In the Matter of:)	
)	Docket Nos. 50-275-OLA
PACIFIC GAS AND ELECTRIC COMPANY)	and 50-323-OLA
)	ASLBP No. 86-523-03-LA
(Diablo Canyon Nuclear Power Plant,)	
Units 1 and 2))

SIERRA CLUB RESPONSE TO FIRST SET OF INTERROGATORIES
AND REQUEST FOR PRODUCTION OF DOCUMENTS
FROM PG&E AND THE NRC

TECHNICAL DETAILS OF THE PROPOSED HIGH DENSITY RERACKING AT DIABLO CANYON THE SEISMIC PROBLEM

Figure 1

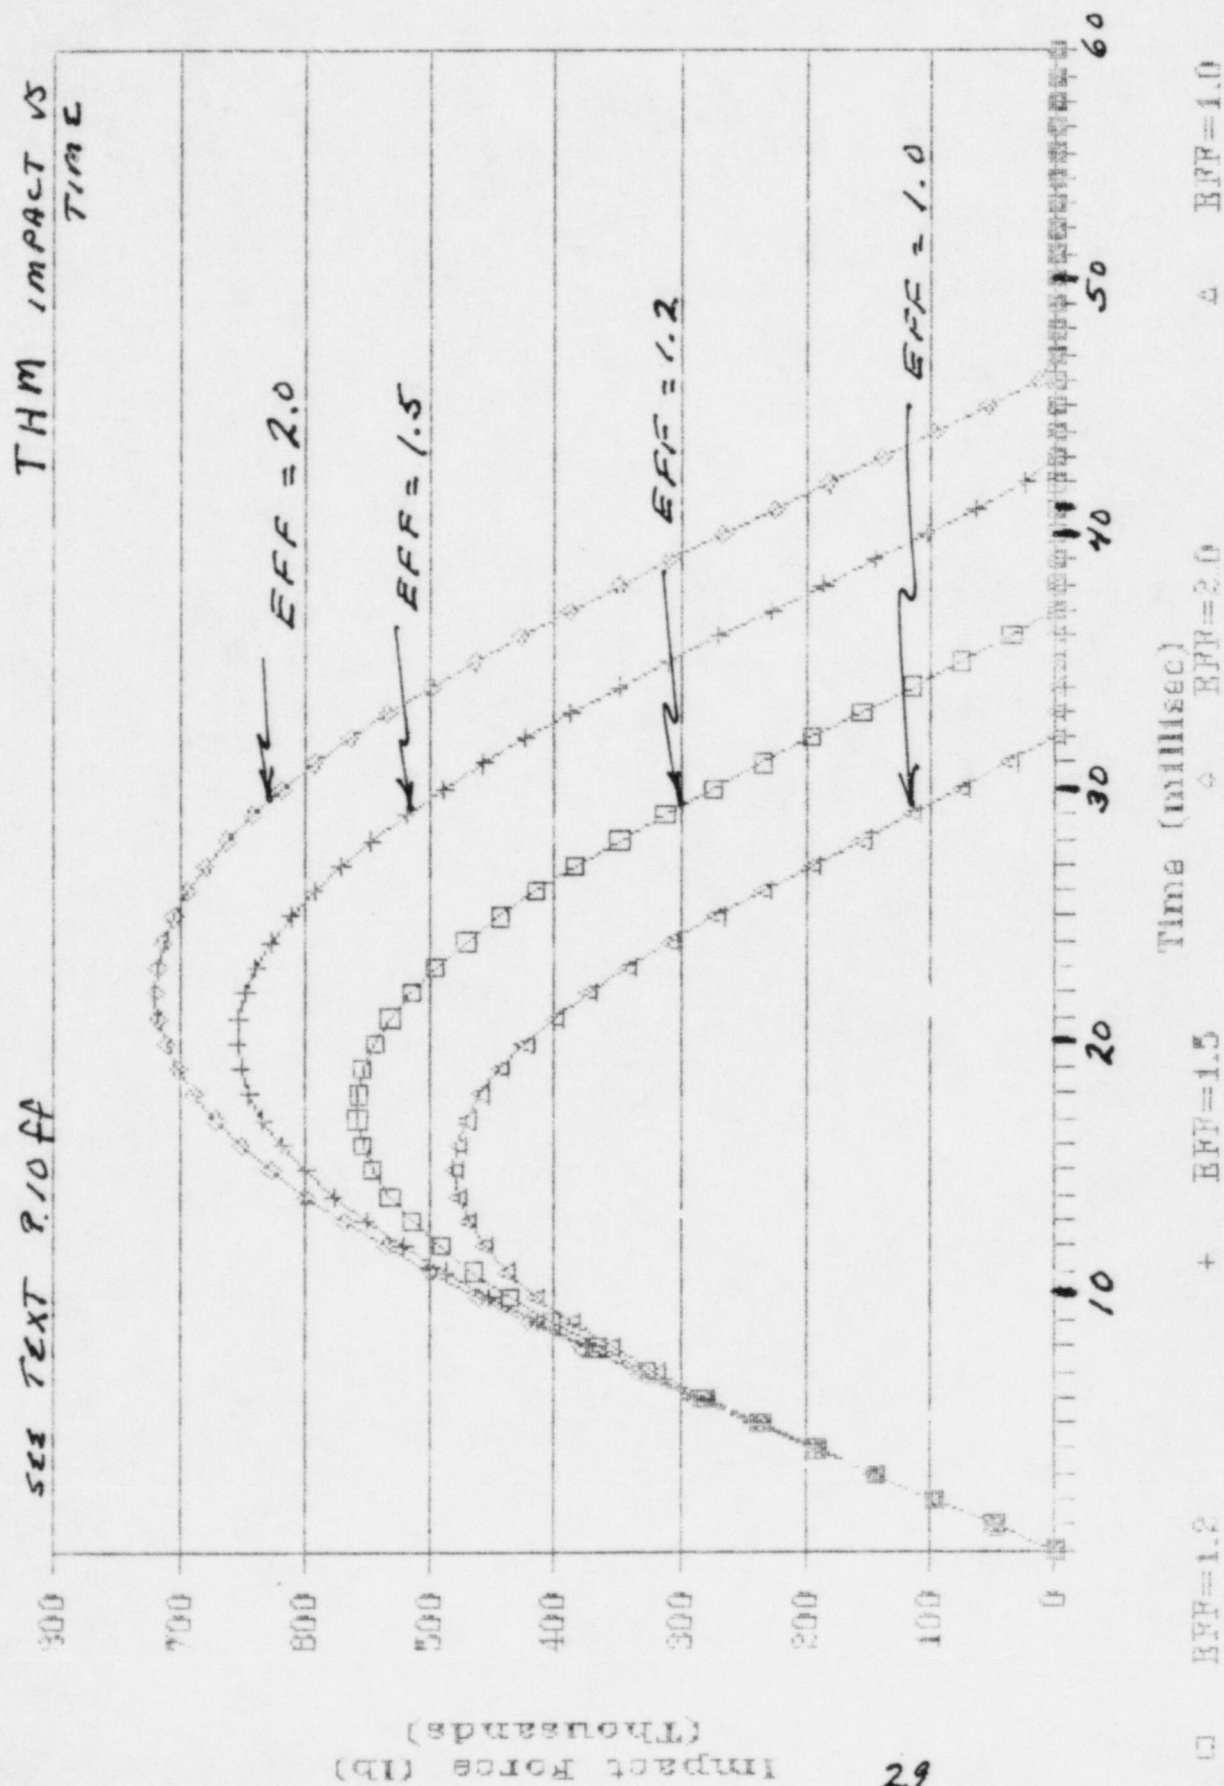
The results of this analysis are shown in Figure 1 where the impact force on the rack is plotted as a function of time for various values of EFF. We make no claim at this time as to what a reasonable choice of EFF should be. We note only that any value larger than 1.0 will serve to increase the maximum impact force on the rack for collisions having the same impact velocity.

Figure 2

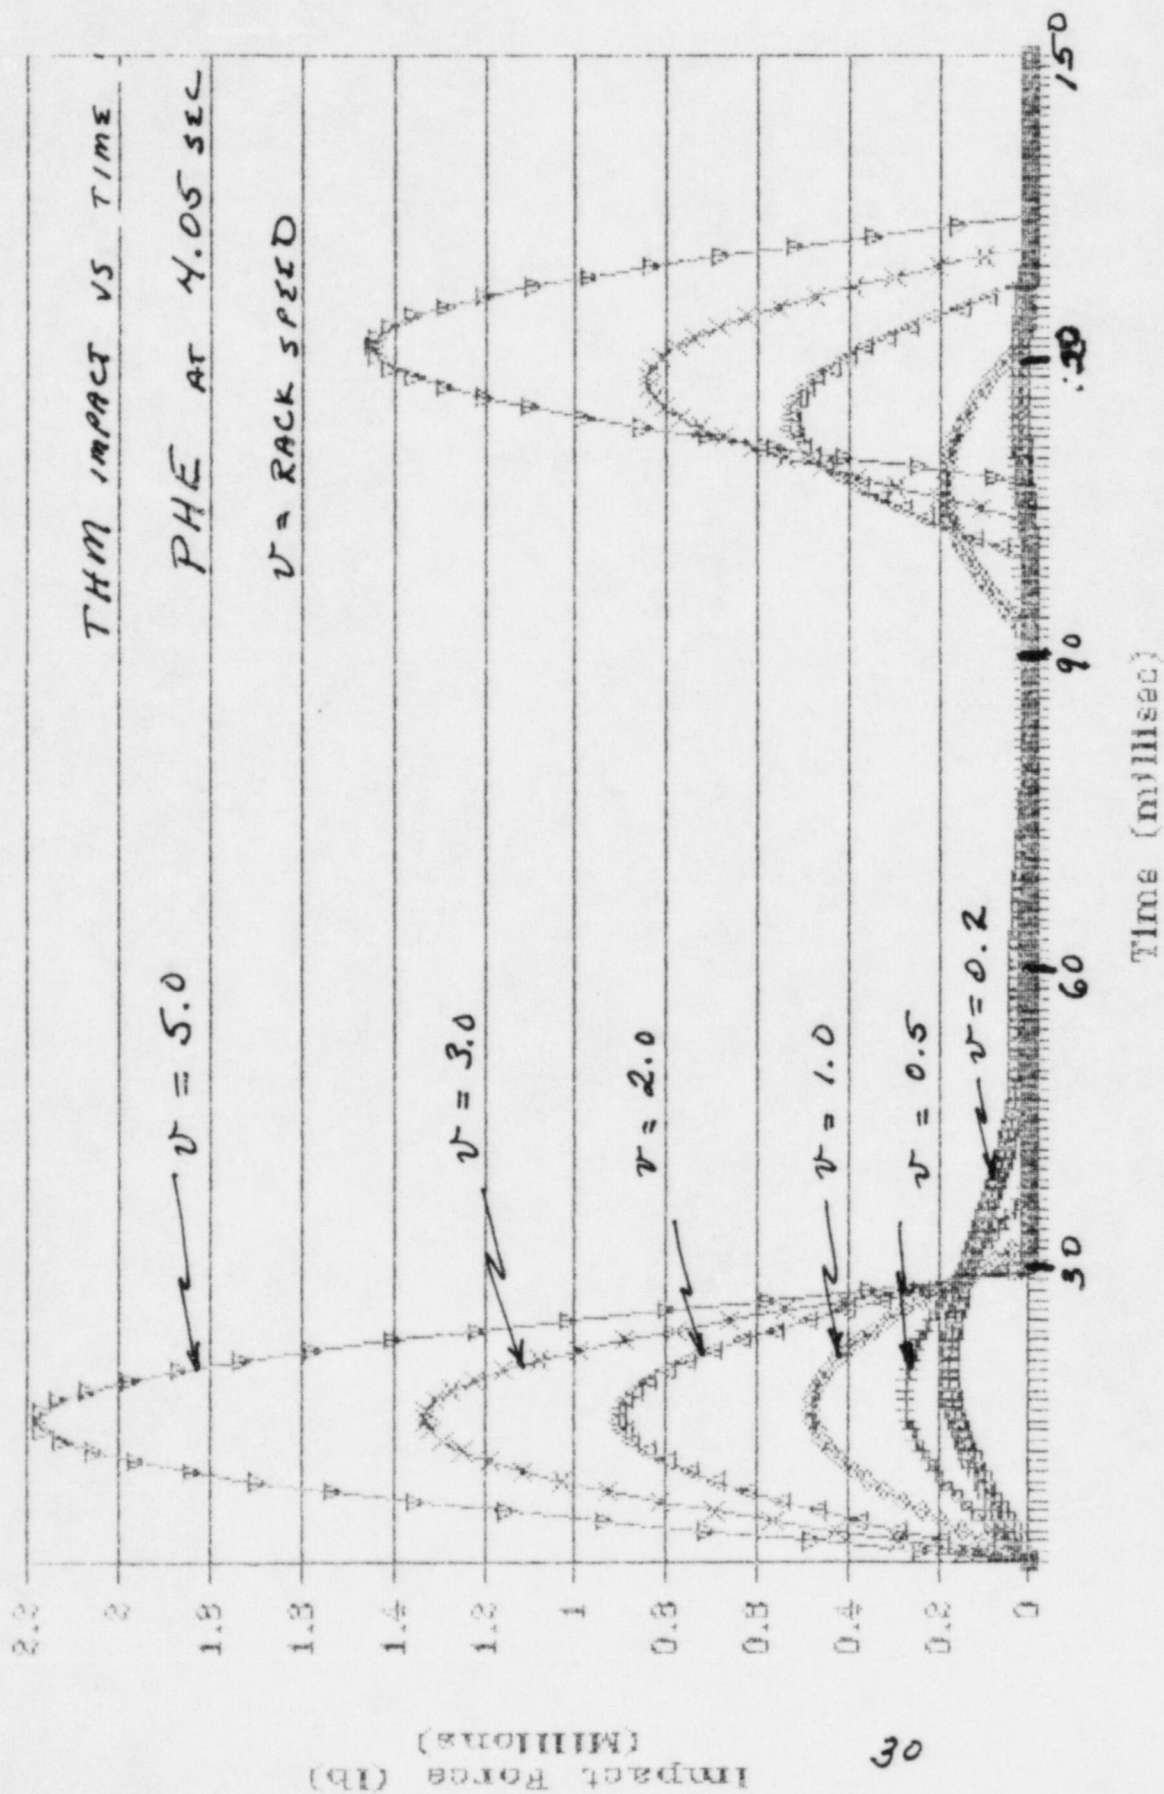
If we compare the analytical results from Table 1 to the THM results for comparable collisions as read from Figure 2, we find the latter approximately 33% smaller than the initial result. Thus it is clearly seen that the inclusion of effects relating to friction, non-constant wall acceleration, independently moving fuel, etc., while lowering the expected maximum impact force somewhat, do not change the qualitative results of the analytical model. Contrary to the claims of certain reviewers of the earlier work, (Ref. 8) the analytical model is quite useful in understanding the collision process.

Figure 2 shows the results of the THM plotting impact force as a function of time for various values of impact velocity with $EFF = 1.0$. The results show that a collision of a rack with a wall at a relative velocity of

approximately 3 inches/sec would result in an impact force which exceeded the manufacturer's specifications.

FIGURE 3

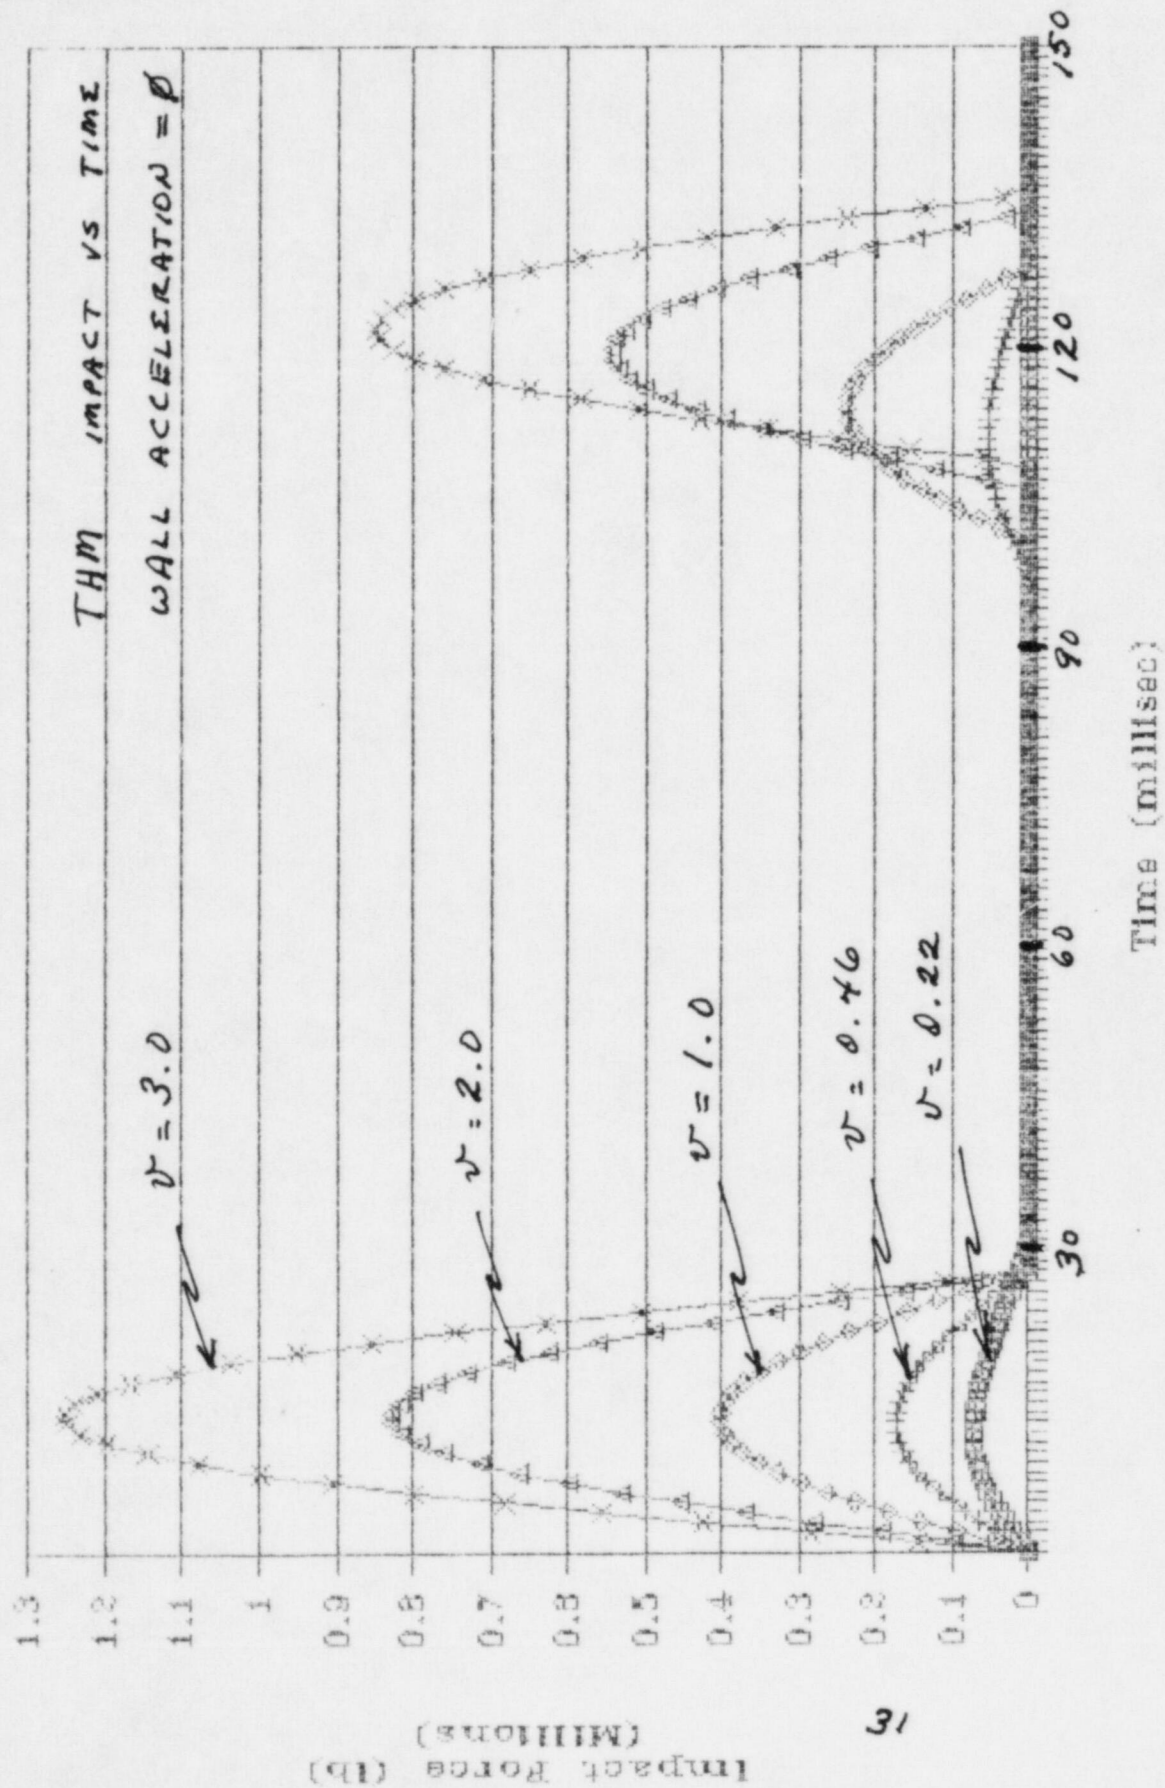
In order to use the THM to analyse rack-rack impacts, a family of curves has been generated for $A = 0$. These curves are shown in Figure 3. The impact forces shown would represent the forces exerted during a head-on rack-rack collision between two racks "out of phase" where the velocity represents the speed of one of the racks. EFF is assumed equal to 1.0. As can be seen from the figure, a speed of about 6 inches per second results in an impact force equal to the limit set by the manufacturer. It can also be seen that if the maximum impact force is 71,400 lbs as claimed by PG&E, the impact speed would correspond to about 3 inches/second.

Further refinements in the model could change these values, of course. Giving the rack an effective mass with $EFF > 1$ would lower the value still farther, for example, as would a two dimensional friction force. On the basis of all the foregoing, it seems reasonable to believe that the impact speeds for rack-rack collisions analyzed by PG&E are no greater than a few inches per second, and that speeds larger than that would result in collisions expected to damage the racks according to manufacturer's specifications. It is unfortunate that the impact velocities were not recorded when the analysis was performed by PG&E so that comparisons with the above predictions could be made.
